PLANNING, ZONING, & BUILDING DEPARTMENT
PZ&B Staff Combination Memorandum: Architectural Commission and Town Council

SUBJECT: ZON-24-014 (ARC-24-004) 334 CHILEAN AVE (COMBO)

MEETING: JANUARY 24, 2024 ARCOM
FEBRUARY 14, 2024 TC

Site Plan. Highlighted areas indicate areas of variance request.

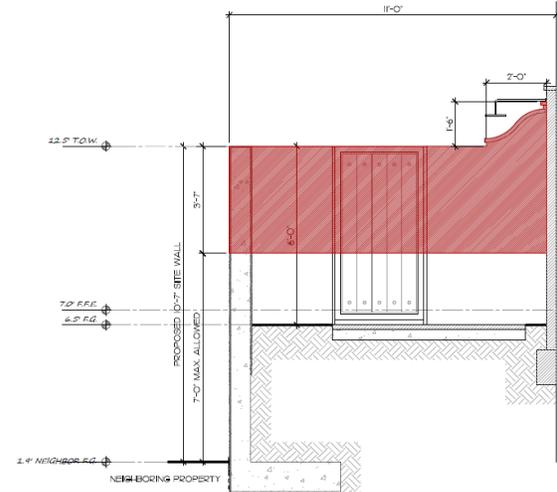
New opaque cypress wood vehicular and pedestrian gates are proposed on Chilean Avenue with a new refuse bin area. Changes for equipment yard areas are also proposed, with variances required for pool heater setback, and variances required to exceed maximum screening wall height. The original application was approved prior to the Town of Palm Beach adopted an ordinance limiting the amount of fill permitted to be added on a given site, allowing this applicant to make plan modifications under the previously approved code condition. The equipment locations are roughly the same as the previous approval, however, staff hypothesizes that the variances required to screen the equipment were not known or completely realized by the applicant at the time of the original application approval.

West side yard variance diagram

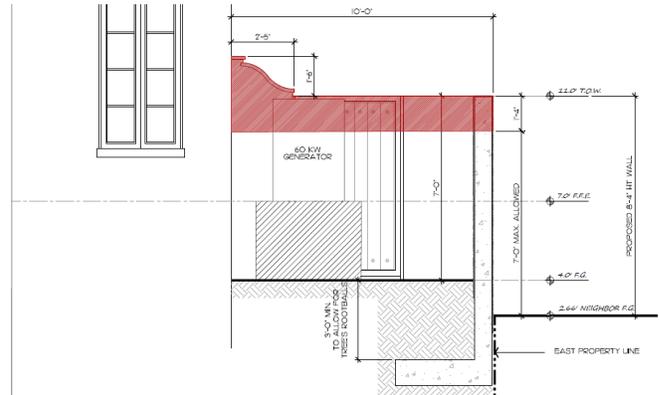
Variance number 1 is for the construction of a site wall in the west side yard with a height of 10' – 7" from lowest grade, in lieu of the 7' maximum wall height permitted.

East side yard variance diagram.

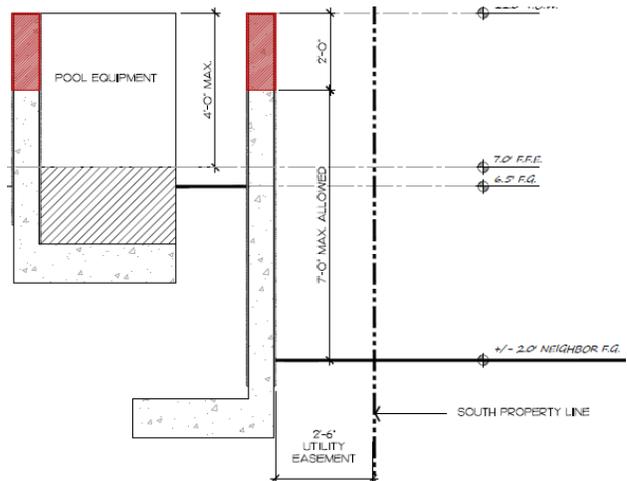
Variance number 2 is for construction of a site wall in the east side yard that is 8' – 4" in height in lieu of the 7 ft maximum height permitted. This wall height is required to adequately screen the generator installed at minimum FEMA elevation from the property to the east.
